# Access Compliance Report

## Public Rights-of-Way

### (Curb Ramps)

Intersection ID: 8857	Main Street: DORTON_ST	Cross Street: N_TRYON_ST	Location: NW
ADA ID: 4DCD5739FB36	Ramp Type: Perp	Initial Pass/Fail: Fail	Overall Compliance: No
Severity Score: 22.5			
Codes/Mitigation Info/Possible Solution		Field Measurements/Component Compliance

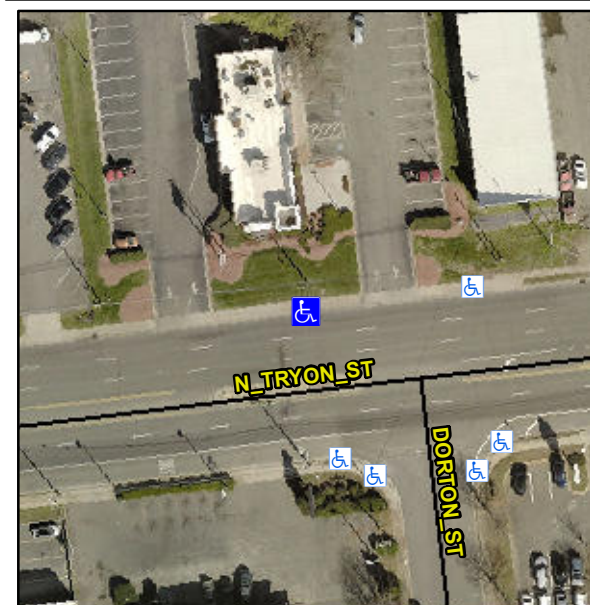
**Not Found, R304.5.1, R304.2.2, R304.5.3**

Compliance	Description	Data	Compliance	Description	Data
N/A	Ramp Length (in)	57.5	No	Ramp Slope (%)	8.9
No	Ramp Width (in)	47.0	No	Ramp XSlope (%)	4.0
N/A	Flare Type LT	N/A	N/A	Flare Type RT	N/A
N/A	Flare Slope LT (%)	N/A	N/A	Flare Slope RT (%)	N/A
N/A	Flare Traversable LT?	N/A	N/A	Flare Traversable RT?	N/A
N/A	Landing Length (in)	N/A	N/A	DWS Provided?	N/A
N/A	Landing Width (in)	N/A	N/A	DWS Contrast?	N/A
N/A	Landing Slope (%)	N/A	N/A	DWS Length (in)	N/A
N/A	Landing X Slope (%)	N/A	N/A	DWS Full Width?	N/A
N/A	Landing Curb? (Y/N)	N/A	N/A	DWS Offset (in)	N/A
N/A	Shared Landing?	N/A			
N/A	Gutter Ponding?	N/A	N/A	Gutter Slope (%)	N/A
N/A	Gutter Lip Ht (in)	N/A	N/A	Gutter X Slope (%)	N/A
N/A	Painted X Walk1?	No	N/A	Painted X Walk2?	N/A
	X Walk 1 Direction	To S		X Walk 2 Direction	N/A
N/A	X Walk 1 Width (in)	N/A	N/A	X Walk 2 Width (in)	N/A
	X Walk 1 Slope (%)	2.7		X Walk 2 Slope (%)	N/A
	X Walk 1 X Slope (%)	2.4		X Walk 2 X Slope (%)	N/A

**Remove & Replace Entire Ramp.**
